AS-BUILT BASELINE MONITORING REPORT

LONE HICKORY MITIGATION SITE

DMS Project No. 97135

RE: Final As-built Baseline Monitoring Document and Record Drawings for the Lone Hickory Mitigation Site
Yadkin River Basin – CU# 03040101 – Yadkin County
DMS Project ID No. 97135
Contract # 006897

UT1
 Stream Plan and Profile

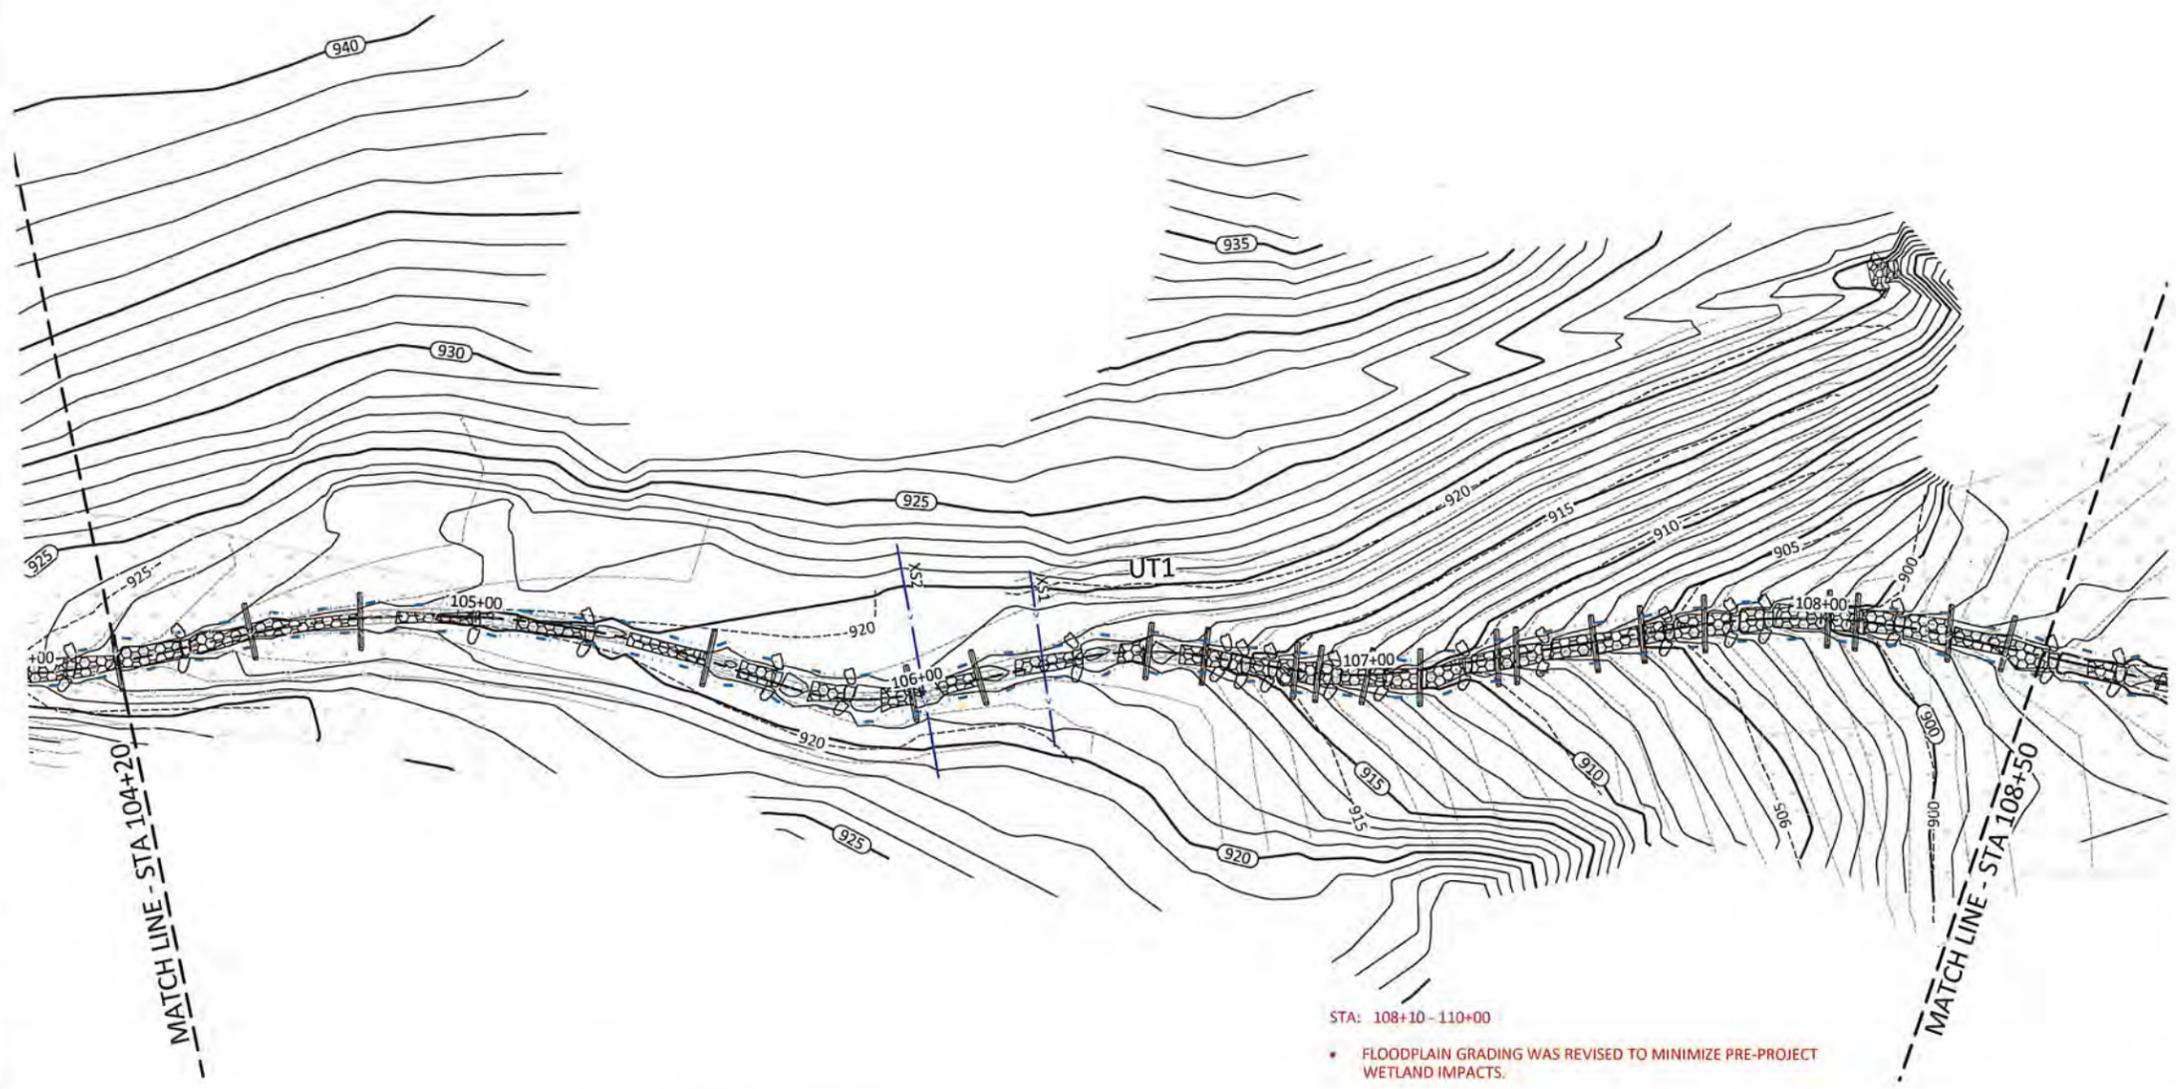
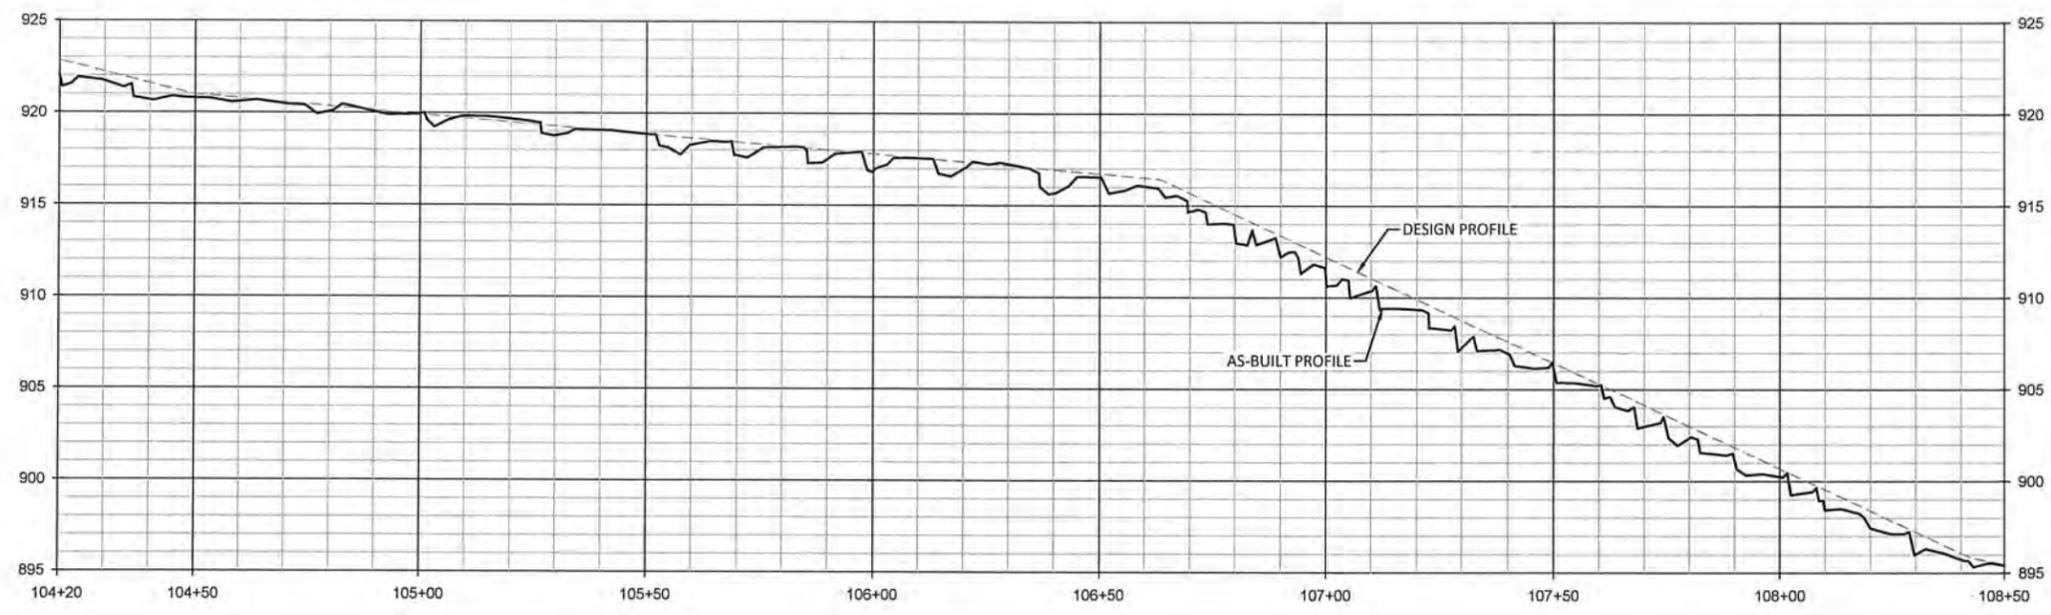
STA: 108+10 - 110+00
 • FLOODPLAIN GRADING WAS REVISED TO MINIMIZE PRE-PROJECT WETLAND IMPACTS.

UT1
 Stream Plan and Profile

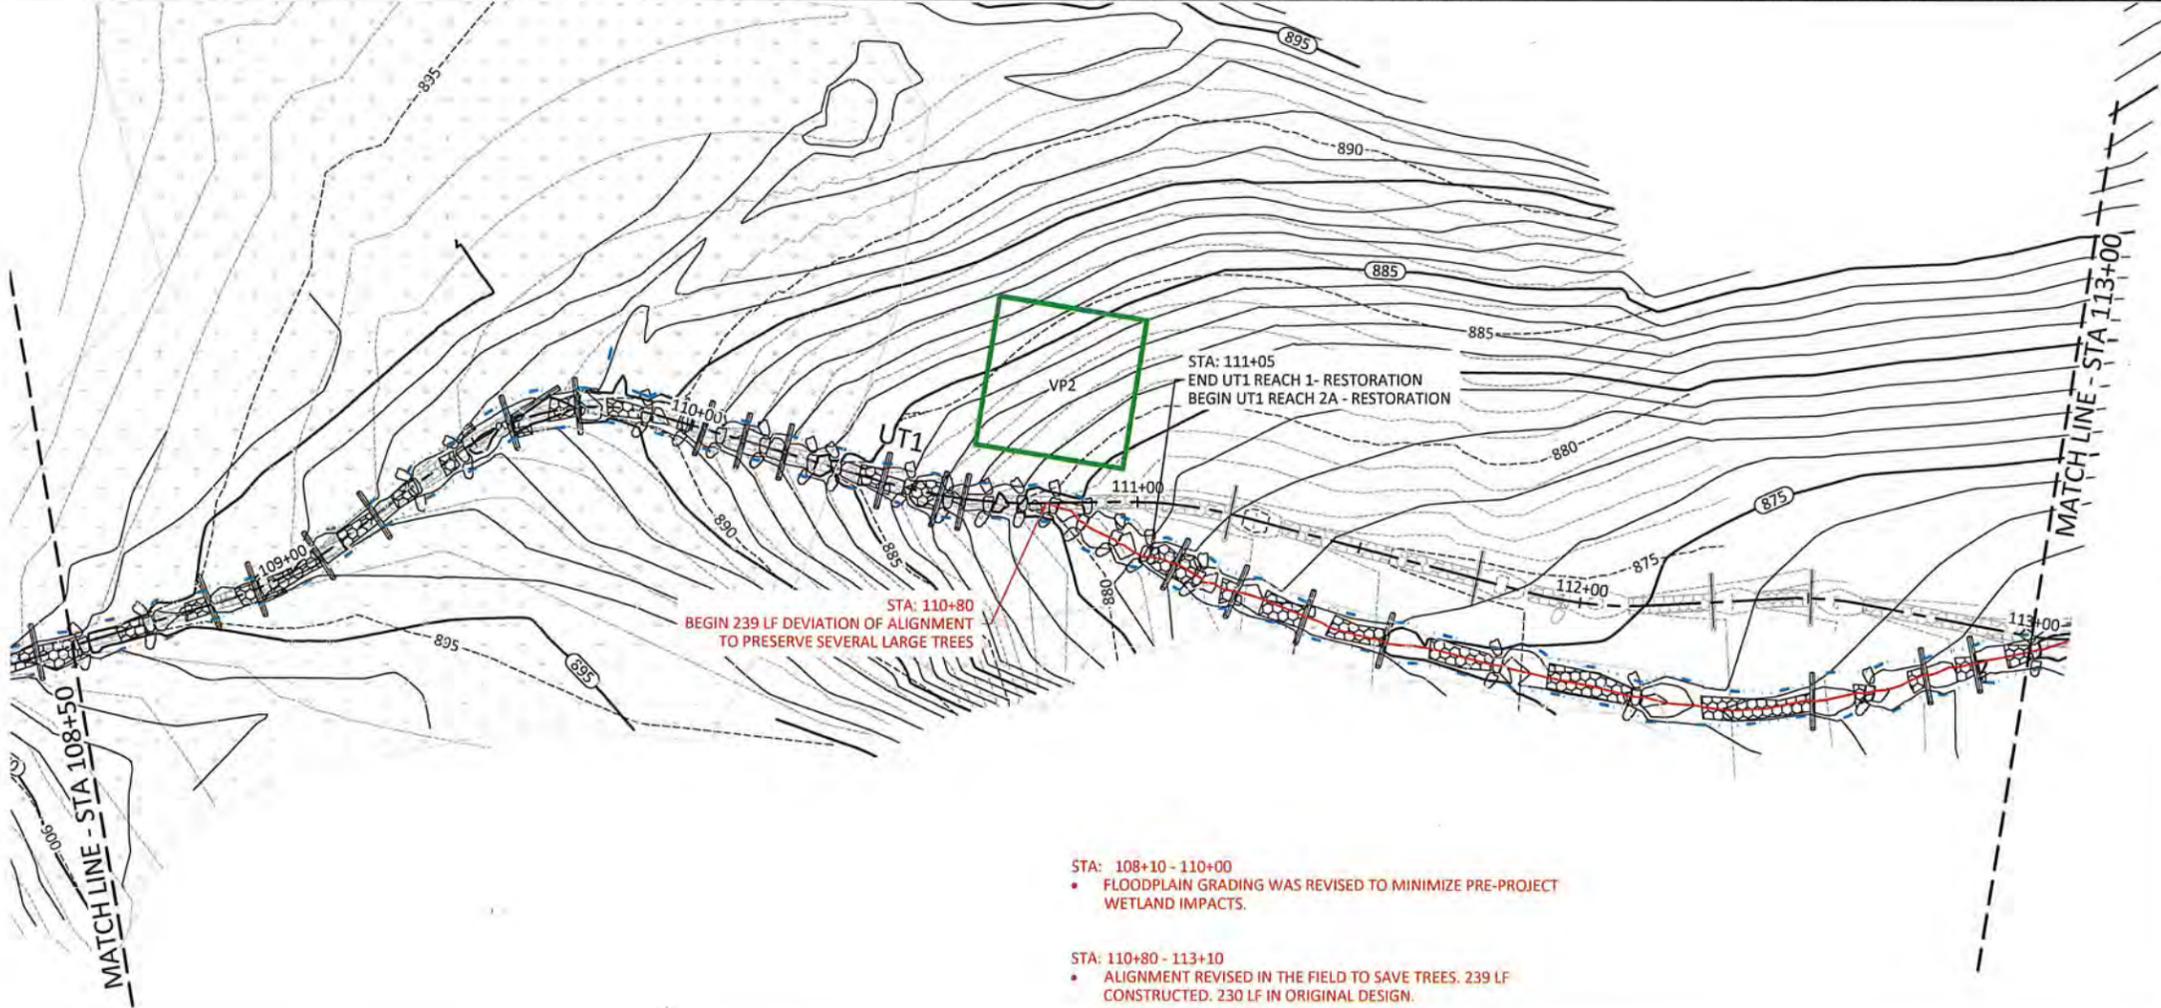
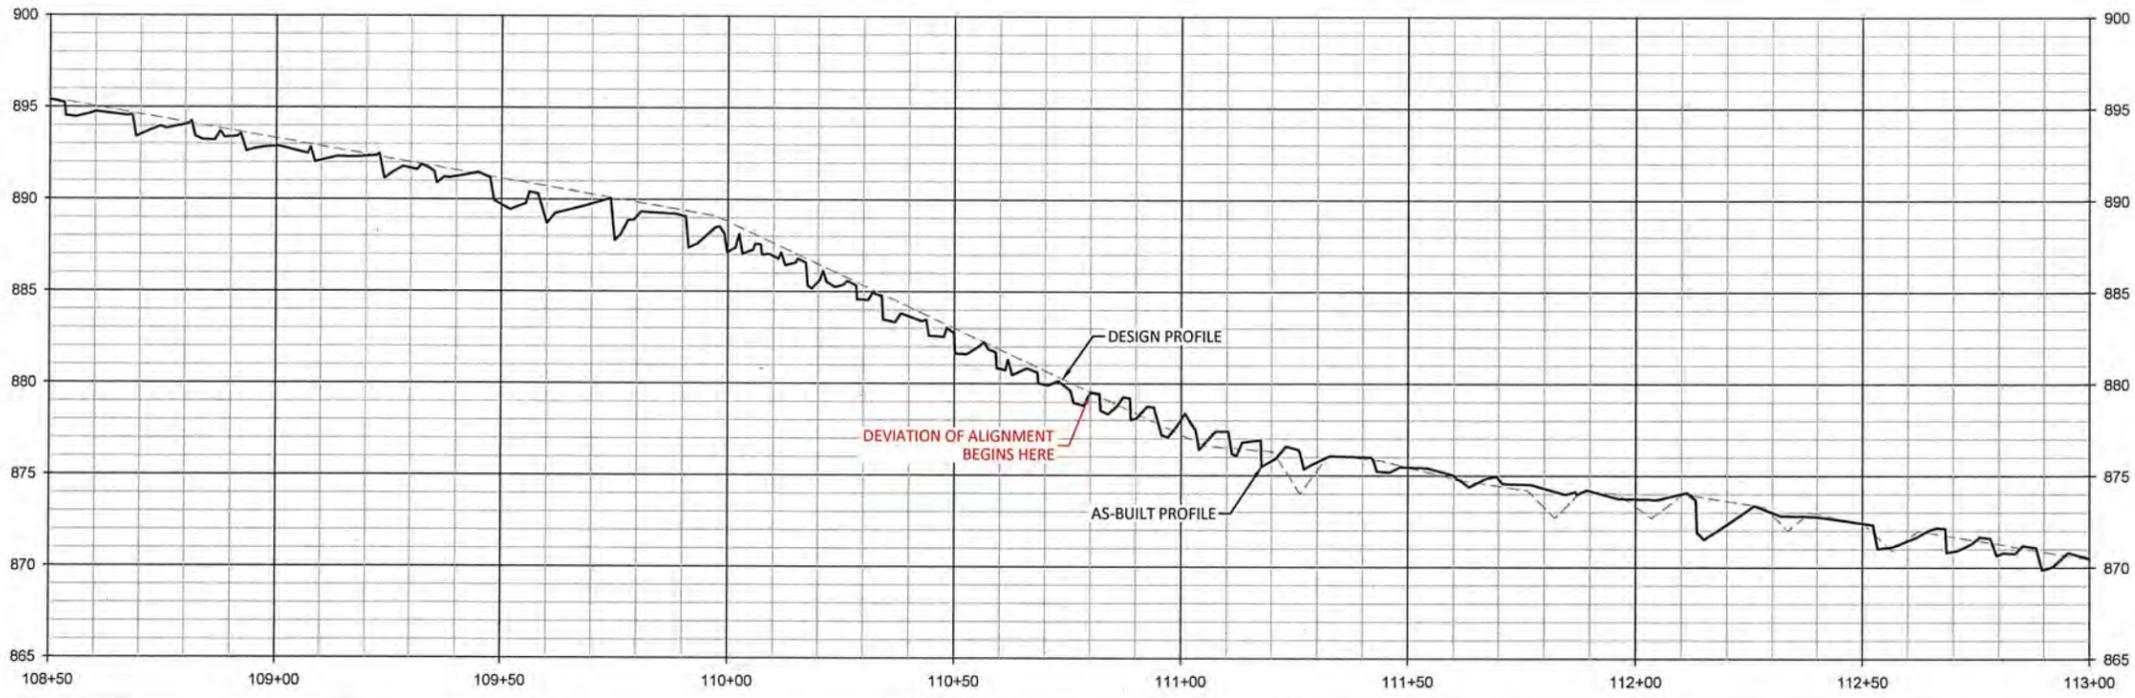
STA: 110+80
 BEGIN 239 LF DEVIATION OF ALIGNMENT
 TO PRESERVE SEVERAL LARGE TREES

- STA: 108+10 - 110+00
 • FLOODPLAIN GRADING WAS REVISED TO MINIMIZE PRE-PROJECT WETLAND IMPACTS.
- STA: 110+80 - 113+10
 • ALIGNMENT REVISED IN THE FIELD TO SAVE TREES. 239 LF CONSTRUCTED. 230 LF IN ORIGINAL DESIGN.
